## APPLICATION FOR MODIFICATION ASSESSMENT REPORT

<b>Application Number:</b>	Mod2024/0705
<b>Responsible Officer:</b>	Anais Sarkissian
<b>Land to be developed (Address):</b>	Lot B DP 316404, 231 Whale Beach Road WHALE BEACH NSW 2107
<b>Proposed Development:</b>	Modification of Development Consent REV2021/0034 granted for Review of Determination of Application DA2020/0442 for demolition works and construction of a Mixed Use Development comprising Shop Top Housing and retail premises, with associated carparking, landscaping and strata subdivision
<b>Zoning:</b>	E1 Local Centre
<b>Development Permissible:</b>	Yes
<b>Existing Use Rights:</b>	No
<b>Consent Authority:</b>	Northern Beaches Council
<b>Delegation Level:</b>	DDP
<b>Land and Environment Court Action:</b>	No
<b>Applicant:</b>	SJB Planning Pty Ltd

This modification application seeks consent for modifications to the approved mixed-use development authorised under REV2021/0034. These modifications relate predominantly to improving amenity for the occupants of the building, to ensure compliance with relevant Australian Standards, to satisfy engineering requirements, or modify the development so that it is brought into conformity

**Figure 2: Modified overland flow path as proposed**

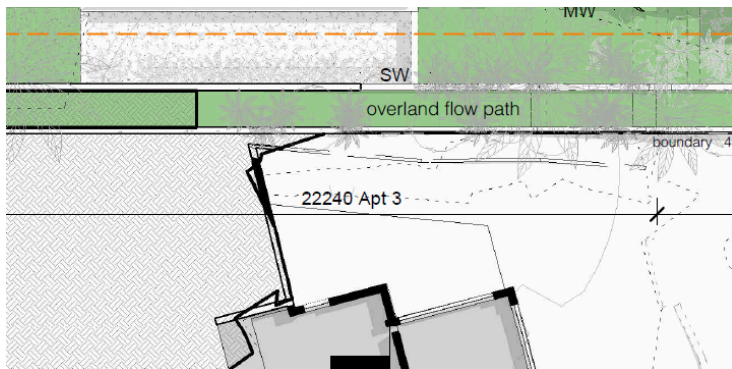
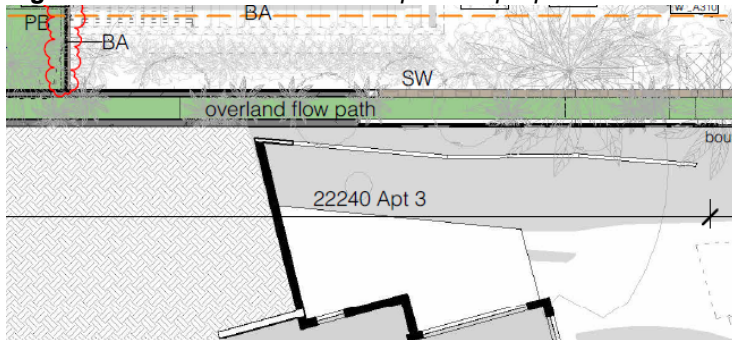
*The submissions raised concerns over the reduction in the width of the overland flow path from 1m to 0.6m and that it will not be adequate, resulting in water pouring over to the neighbouring property. Concern is also raised over the impacts of this change on the health of the neighbouring hibiscus tree to the south.*

The changes to the overland flow path have been assessed by Council's Development Engineer, who is satisfied that the width of the overland flow path is consistent with the design plans submitted by the Civil Engineer and is acceptable (refer Figures 1 and 2 below). The overland flow path was adjusted in width to comply with Condition 19 of consent REV2021/0034, requiring the width of the overland flow path to be reduced from 1m to 0.6m, and the setback between the overland flow path and the southern elevation to be increased by 0.4m. Condition 26 also requires the perimeter walls of the overland flow path to be watertight to ensure no flows enter the site or adjoining property. As such, Council's Development Engineer has advised that the modified design will be less likely to result in overland flows onto the neighbouring property than the previous design. The Project Architect confirmed that the levels of the overland flow path have not changed. Council's Landscape Officer has reviewed the modified plans with respect to the neighbouring tree in question and advised that the impact to the southern neighbouring trees were assessed by the Arborist at the boundary line in 2021 and therefore no further impact is foreseen. Condition 36 has been amended as part of this consent to require the Project Arborist to supervise the construction of the overland flow path along the southern boundary, including any associated retaining walls, within the tree protection zones of any neighbouring trees. It is noted that the Arboricultural Assessment approved as part of the original application stated that the location of concrete footings for the overland flow path wall will need to allow for the low likelihood that woody roots are encountered and that an arboriculturist will need to supervise these works. The recommendations of the original Arboricultural Assessment shall remain in place and be adhered to.

**Figure 4: Proposed Basement Plan**

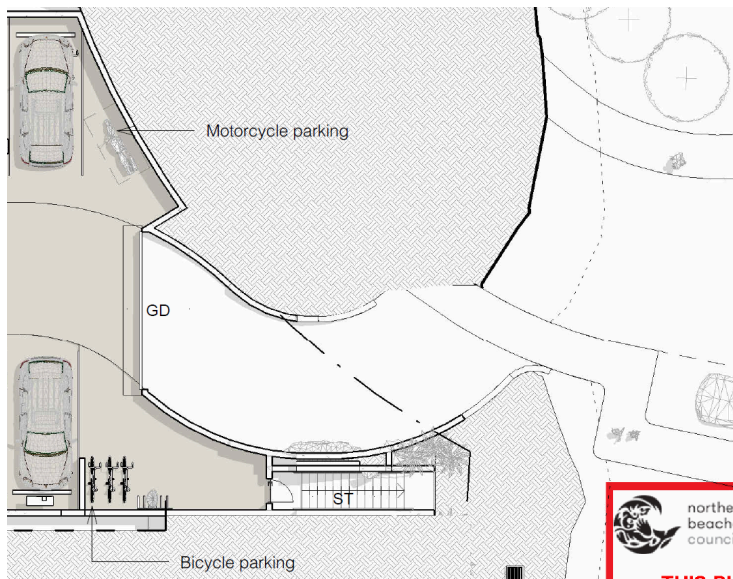
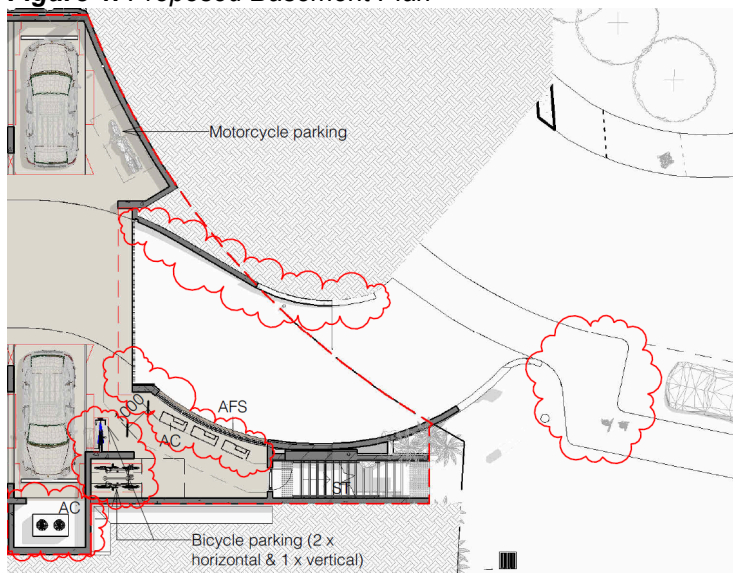
*The submissions raised concerns that the change to the footpath/parking bays forces pedestrians further towards traffic on Surf Road, increasing the likelihood of an accident. The submissions note that the Loading Zone should remain where it was originally approved just east of the driveway, and that placing it on the west of the driveway would obstruct the line of sight of drivers coming down Surf Road.*

The footpath has been adjusted slightly to accommodate parking bay lengths that are compliant with Australian Standards; the changes do not force pedestrians further towards Surf Road, but rather improve safety by increasing the width of the footpath at the bend, as evident in Figures 3 and 4 below. The loading bay as approved has not changed and has always been located west of the driveway.

**Figure 5: Approved southern elevation at boundary**

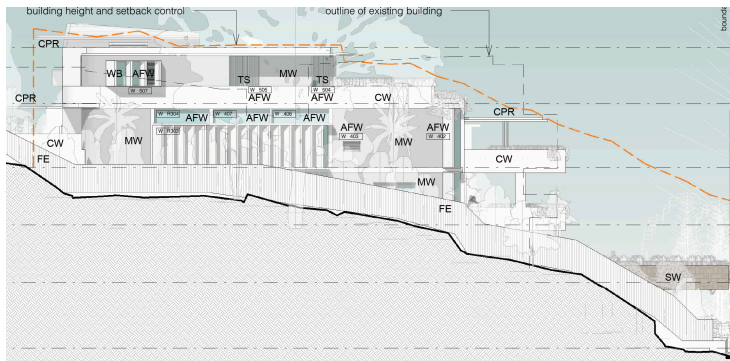
*The submissions raised concerns that the whole building has been pushed closer to the southern boundary at the eastern side, further spoiling the enjoyment of the neighbouring property.*

The setback of the building to the southern boundary is generally the same as approved in relation to the residential units. However, minor additions to the building have brought some components closer to the southern boundary - the inclusion of the AC at the basement, and lift and stairs to the outdoor seating area at the ground floor to comply with access and mobility design standards. These changes are not considered to have adverse amenity impacts due to the changes being below the existing ground level (refer Figure 5 and 6) and these components not directly interfacing the neighboring dwelling. The new sprinkler pump tank is entirely below ground and required for fire services. The area above the tank on Level 3 has replaced an entirely paved area to the boundary with a garden bed to the boundary, thereby softening the built form of the building.

**Figure 7: Approved eastern elevation**

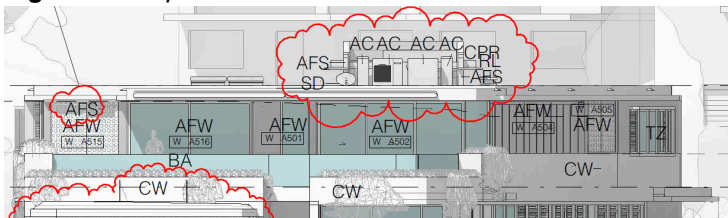
The proposed roof top air conditioning units do not add significant bulk and scale to the approved development as they are contained within the screened area on the roof, as evident from Figures 7 and 8 below.

**Figure 10: Proposed Level 3 Plan**

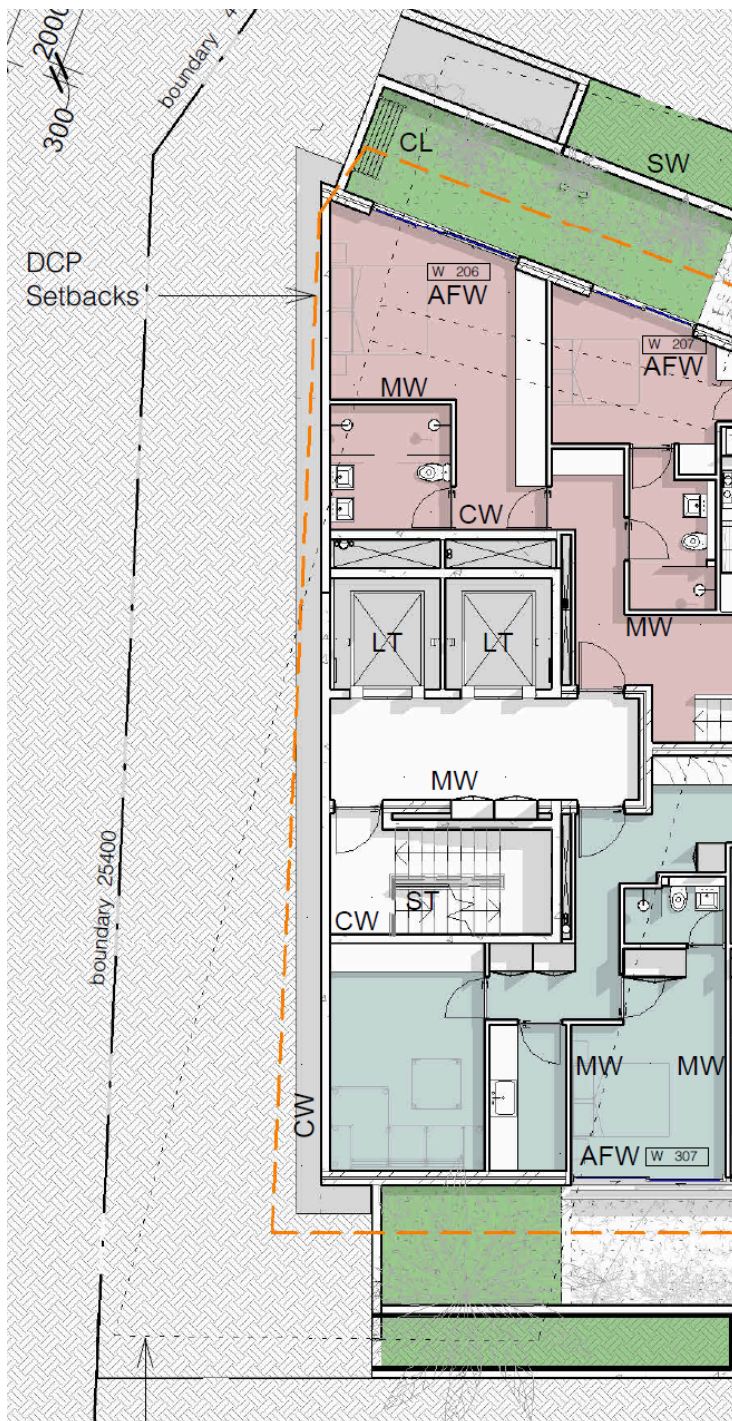
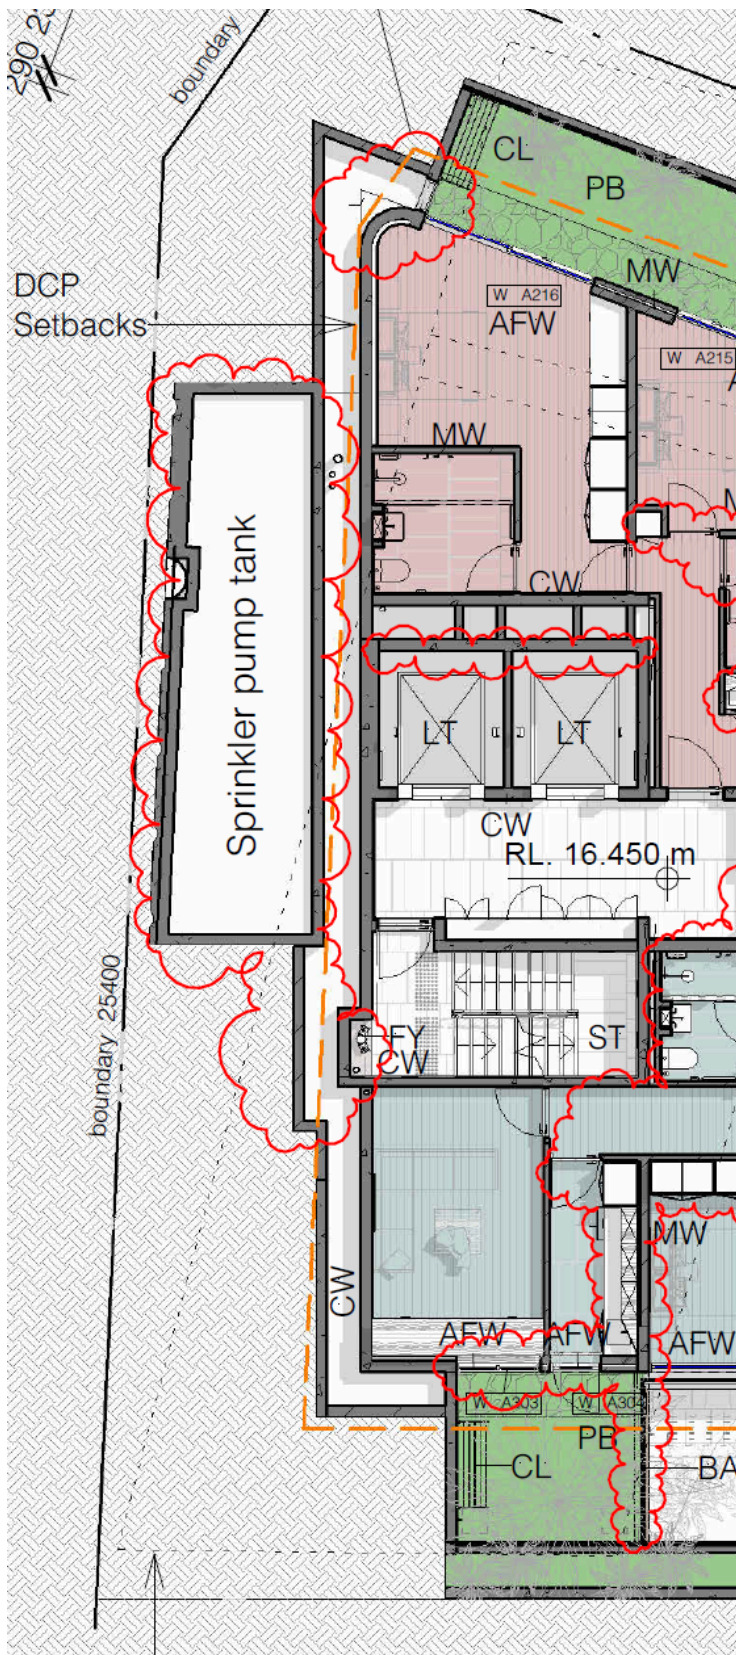
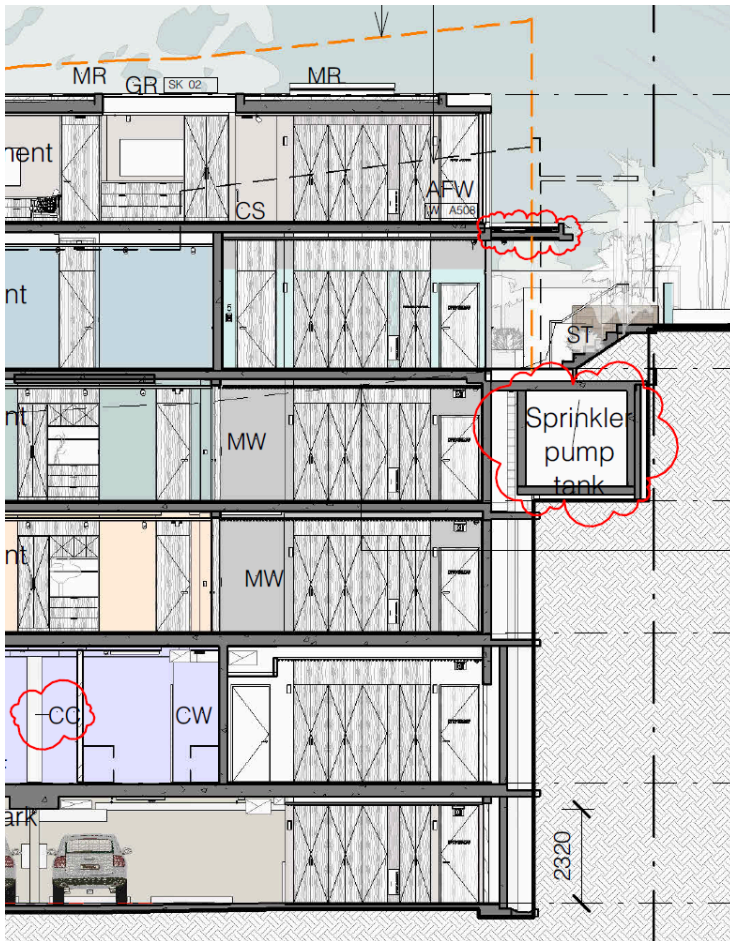
The proposed modifications include a sprinkler pump tank that is set back 0.3m from Whale Beach Road. It is important to note that the proposed sprinkler tank sits below existing ground level and is therefore not visible from the streetscape. The setback of the face of the development to Whale Beach Road remains unchanged. Refer Figures 9-11 below.

**Figure 13: Proposed Basement Plan**

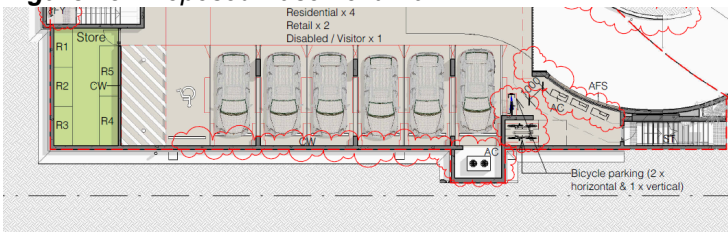
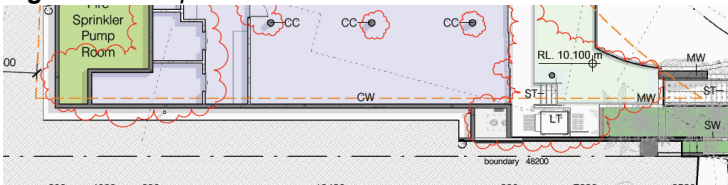
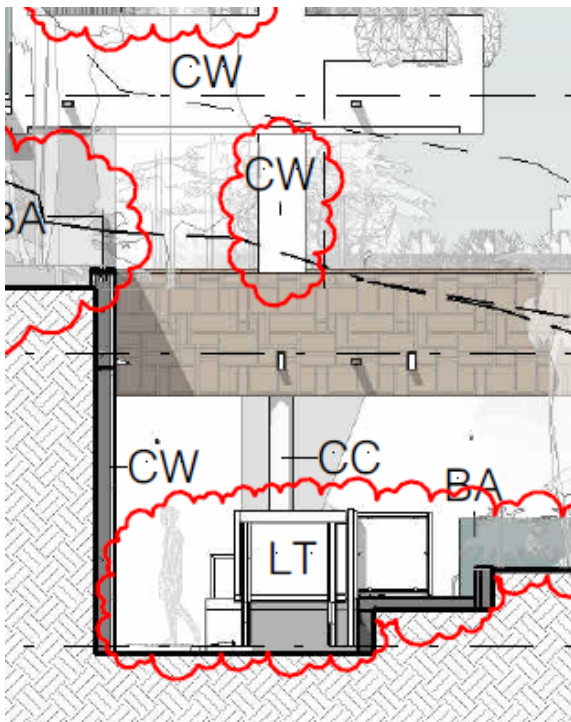
The basement and ground levels were approved with a 2.5m setback to the southern side boundary. The proposal as modified has a minimum setback of 0.7m at the basement level and 0.8m at the ground level due to the inclusion of the air conditioner and lift to the outdoor seating area to comply with AS1428.1 Design for access and mobility, as evident in Figures 13 and 14 below. The remainder of the building maintains the approved setback of 2.5m from the southern boundary at the basement and ground floor levels.

It is important to note that the ground floor sits approximately 5.3m below the existing ground level and 6.8m below the height of the fence, as evident in Figure 15 below. As such, these added components pose minimal amenity impacts for adjoining properties.
